Product Change Notification

PCN-IFC-7816-2022

Description for Product Change Notification

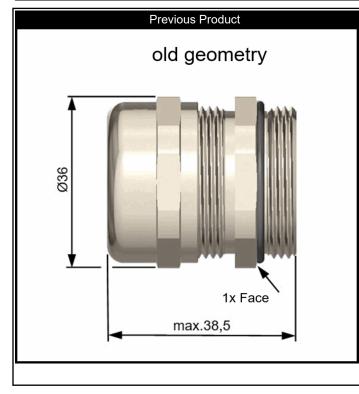
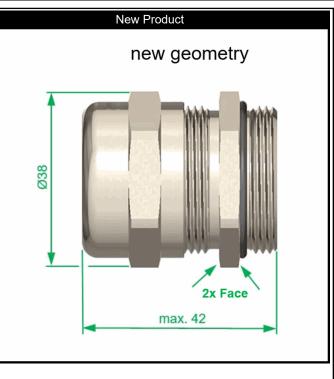
As part of our ongoing improvement process, we have enlarged the faces for landing a wrench on the mounting flange and union/clamping nut on our nickel-plated brass M32 cable glands. The larger face has resulted in a slightly longer profile, increasing the overall max length from 38.5mm to 42mm. This change will improve the ease of installation of the cable gland on panels and rectangular connectors.
